576 STEP GENERATOR INTERMITTENTLY SKIPS STEPS

REPLACEABLE ELECTRICAL PARTS AND SCHEMATIC CHANGES

DIAGRAM  STEP GENERATOR

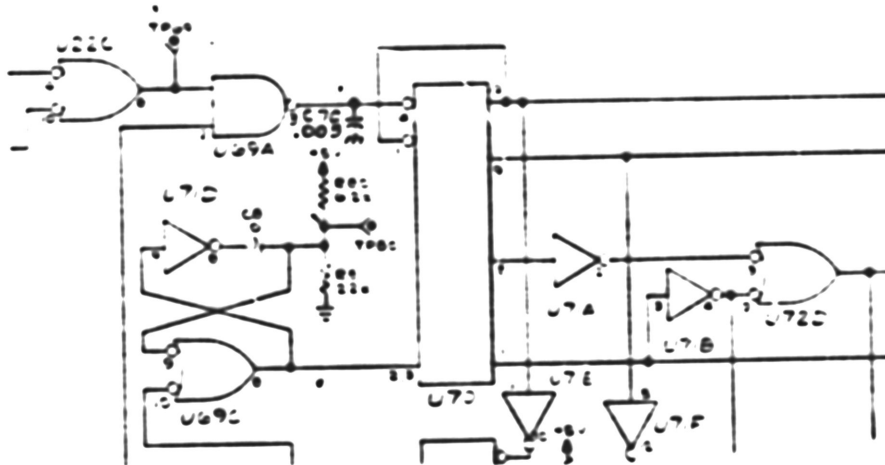
Manufacturing has found a problem in the 576 whereas the Step Generator would intermittently skip steps. To alleviate the situation, a Modification, M41067 was generated to install a capacitor, C-70 from U70, Pin 14 to ground (see illustration below). This mod was implemented by Manufacturing on all products starting at Serial Number B327878.

Add C70 from pin 14 of U70 to ground.

ADD:

C70 283-0110-00 CAP.,FXD,CER DI:0.005UF,+80-20%,150V
